# UNITED STATES PATENT AND TRADEMARK OFFICE

APPLICATION NO.	FILING DATE	FIRST NAMED INVENTOR	ATTORNEY DOCKET NO.	CONFIRMATION NO.
10/607,550	06/27/2003	Edward A. Burton	INTEL-021	7414
34610	7590	06/12/2006	EXAMINER	
FLESHNER & KIM, LLP P.O. BOX 221200 CHANTILLY, VA 20153			NGUYEN, DAO H	
			ART UNIT	PAPER NUMBER
			2818

<b>Office Action Summary</b>	<b>Application No.</b> 10/607,550	<b>Applicant(s)</b> BURTON ET AL.	
	<b>Examiner</b> Dao H. Nguyen	<b>Art Unit</b> 2818

**4. Claim(s) 31-34, 36, 37, 39, 48-56, and 65-67 is/are rejected under 35 U. S. C. § 102 (e) as being anticipated by U.S. Patent No. 6,885,043 to Smith et al.**

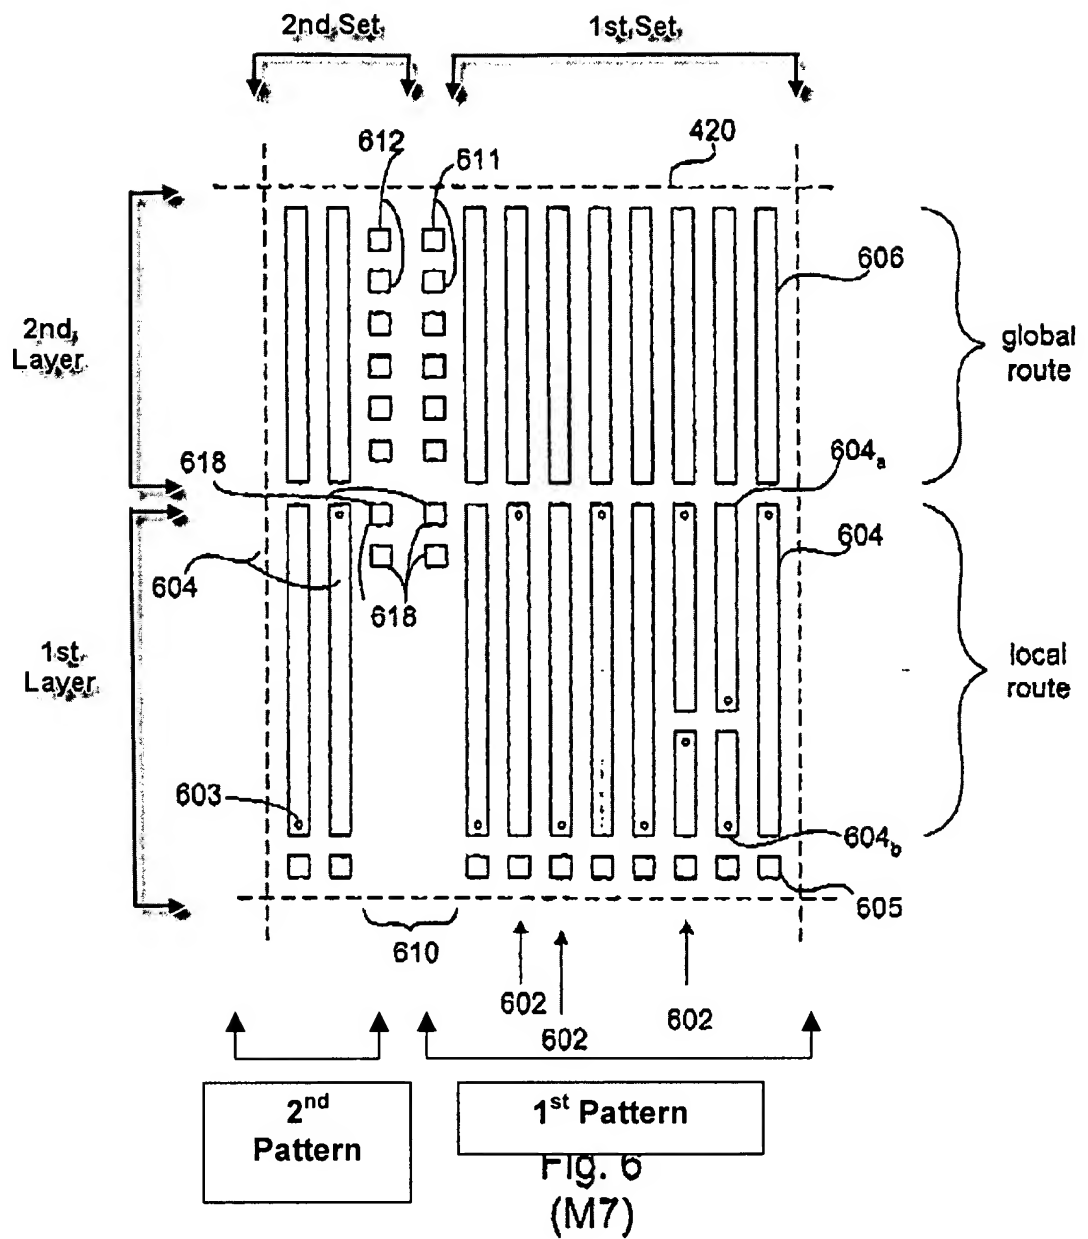
Regarding claim 31, Smith discloses a semiconductor device, comprising:

a first set of signal wires (see figs. 6-8, and the attached figure below), including a first plurality of signal wires 604 distributed in a first layer and a second plurality of signal wires 606 distributed in a second adjacent layer;

a second set of signal wires, including a third plurality of signals wires 604 distributed in the first layer and a fourth plurality of signal wires (606) distributed in the second layer, the first and second sets having a different number of signal wires, with the signal wires in the first set being substantially parallel and arranged in a first pattern, and the signal wires in the second set being substantially parallel and arranged in a second pattern.

Regarding claim 36, Smith discloses the semiconductor device wherein the first and second patterns are alternating patterns (1<sup>st</sup> Pattern and 2<sup>nd</sup> Pattern as shown in the above figure).

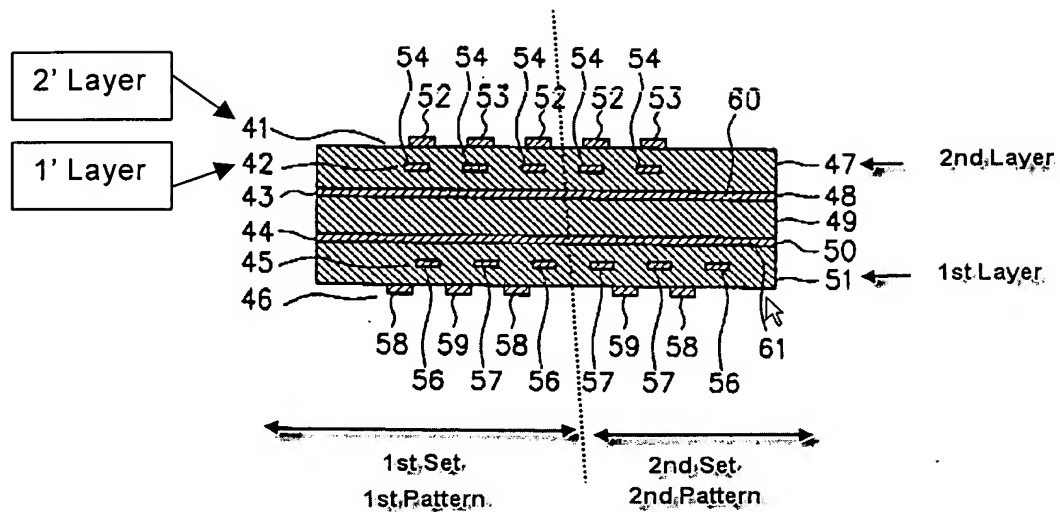
Regarding claim 31, Koya discloses a semiconductor device, as shown in figs. 2, 3 and 6-10, comprising:

a first set of signal wires (on the left of the dash line shown in the attached figures below), including a first plurality of signal wires 74 distributed in a first layer 45 or 74 (alternately, 1' layer 42 or 73) and a second plurality of signal wires 84 distributed in a second adjacent layer 42 or 73 (alternately, 2' layer 41 or 71);

a second set of signal wires (on the right of the dash line), including a third plurality of signals wires 74 distributed in the first layer and a fourth plurality of signal wires 84 distributed in the second layer 73, the first and second sets having a different number of signal wires, with the signal wires 73, 74 in the first set being substantially parallel and arranged in a first pattern, and the signal wires 73, 74 in the second set being substantially parallel and arranged in a second pattern.

F I G. 9

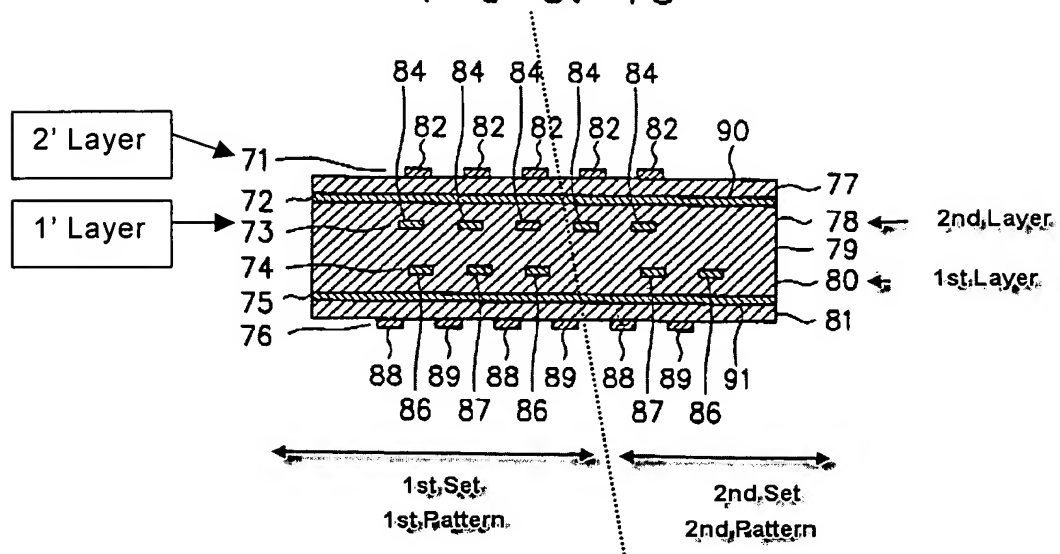
Regarding claim 65, Koya discloses the semiconductor device wherein the first layer is formed over the second layer. See figs. 9, 10.

Regarding claim 66, Koya discloses the semiconductor device wherein the signal lines in the first and second sets are oriented in a same direction. See figs. 9,10.

Regarding claim 67, Smith discloses the semiconductor device wherein the signal lines in the first and second sets are parallel to one another. See figs. 9, 10.
